A Pulse Line Replacement RevX

SD-1003

Evolution Aircraft, Inc February 19, 2025

(1) Fuel line(2) Oetiker clamps

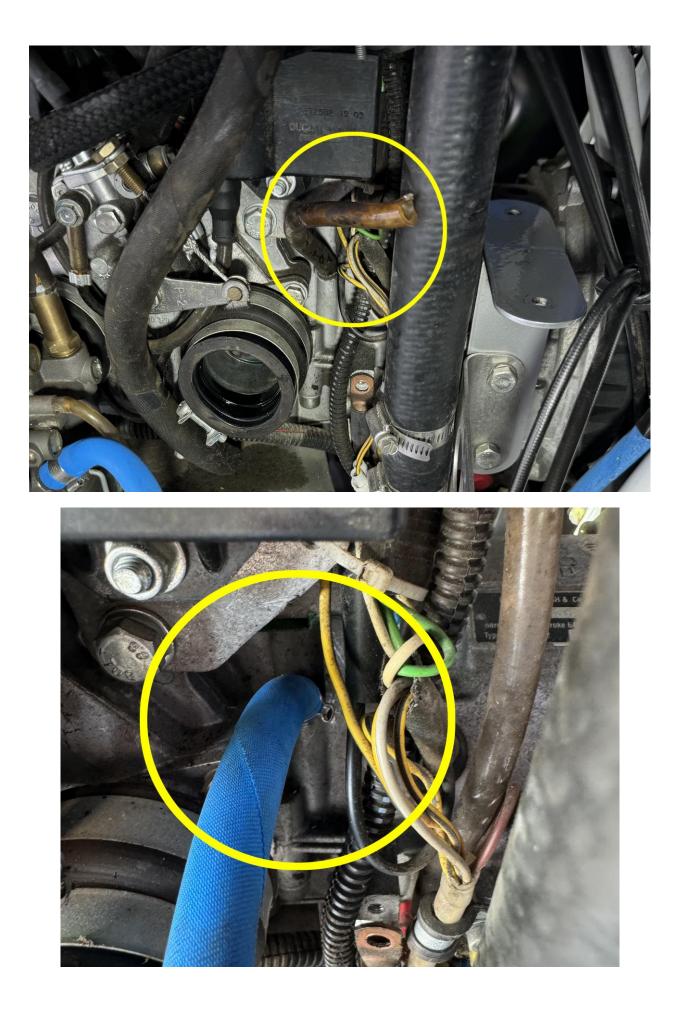
It is possible for the pulse line that powers the mechanical fuel pump to fail within 5 years. Therefore this line is being changed to Aeroquip fuel line and should be checked annually and replaced at 5 years or on condition.

- Remove airbox
- Remove right side carburetor
- Remove airbox bracket
- Remove Adel clamp that holds rotary valve to engine case
- Remove Oetiker clamps on both ends of line
- Replace line
- Install new Oetiker clamps
- Reassemble
